ELECTRICAL POWER - PLACARD INSTALLATION FOR STANDBY ALTERNATOR

Belt tension for the standby alternator has been decreased to reduce side loads on the drive pulley assembly.

CAB-24-04  
Page 1 of 2

Figure 1. Placard Installation (Sheet 1)

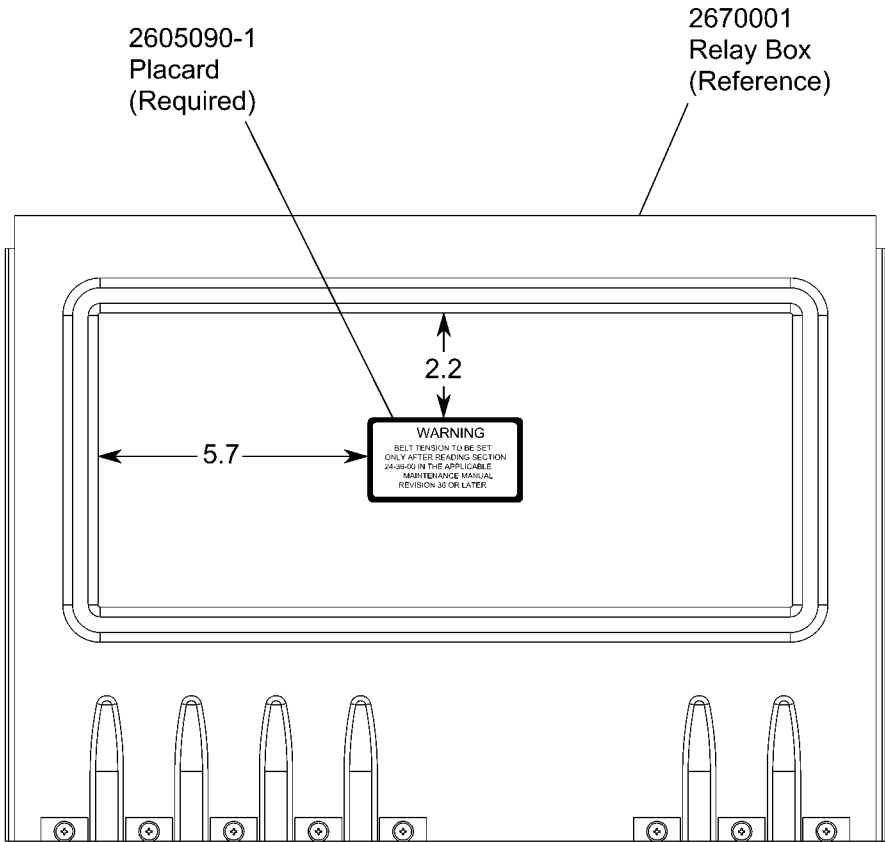
3. (Refer to Figure 1.) Use a clean rag damp with isopropyl alcohol and clean the area where the placard will be installed on the front cover of the electrical power box.

4. (Refer to Figure 1.) Install the 2605090-1 Placard.
5. Close the upper left engine cowl. (Refer to the Model 208 Series Maintenance Manual, Chapter 71, Engine Cowling and Nosecap - Maintenance Practices, Lower Cowl Panel Removal/Installation.)
